Below, please find the 573.6 Defect Information Report for the issue we discussed with you on Monday, February 13, 2006. This issue concerns the VIN decal on some 2006 Victory motorcycles which states an incorrect Gross Axle Weight Rating.

573.6 Defect Information Report

**SUBJECT: INCORRECT TIRE LOADING INFORMATION ON THE VIN
DECAL**

**2006 Victory Vegas Jackpot & 2006 Ness Signature Series Vegas
Jackpot**

Apply this decal over the GAWR portion of the VIN decal on the motorcycle.

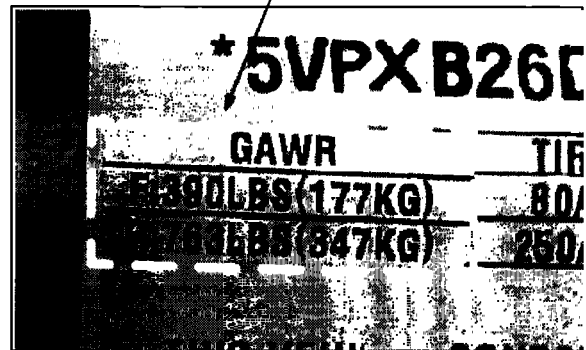
1. Clean the decal with warm soapy water to remove all oil, grease or dirt.
2. Rinse with clear water.
3. Dry decal and surrounding area thoroughly.
4. Carefully remove the new GAWR decal at right and apply it over the GAWR area of the decal on the motorcycle as shown. Be sure all previous GAWR information is covered, and press the decal firmly in place.

Incorrect: F: 405 LBS (184KG)
R: 750 LBS (340KG)

Correct: F: 390 LBS (177KG)
R: 763 LBS (347KG)
